TECH NOTE

Audi, Volkswagen Service Information

BULLETIN: TSB009_AU

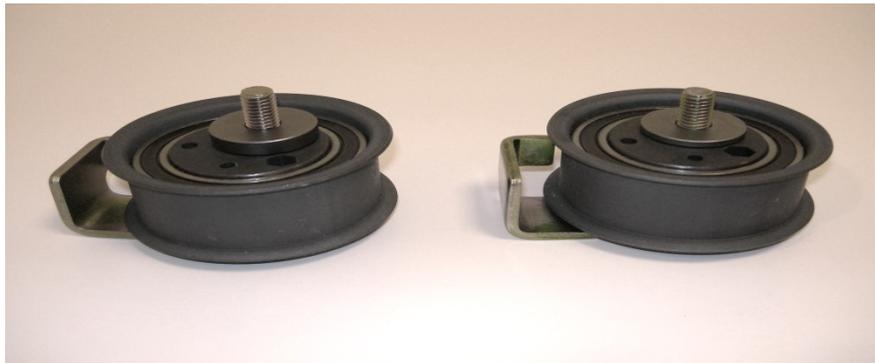
The OE system that is no longer available from the manufacturer is illustrated in Fig #1. The updated system, contained in Gates TCKH317A, which includes the redesigned hydraulic actuator, tensioning roller and 153 Tooth timing belt (Gates T317) is illustrated in FIG #2.

A 152 tooth belt (T291) CANNOT be combined with the updated components pictured below (Fig. 2). And a 153 tooth belt (T317) cannot be placed on the older version of the drive set up without risking engine damage (Fig. 1).

FIG #1 - OLD SYSTEM

152 Tooth Belt

FIG #2 - NEW SYSTEM

153 Tooth Belt

Please be aware that the updated drive system design requires a different timing belt. Those vehicles equipped with the old design will have a 152 tooth timing belt (T291). The updated design makes use of a 153 tooth belt (T317). This 153 tooth belt combined with the components contained in a Gates timing component kit will set the drive in the current OE approved configuration.
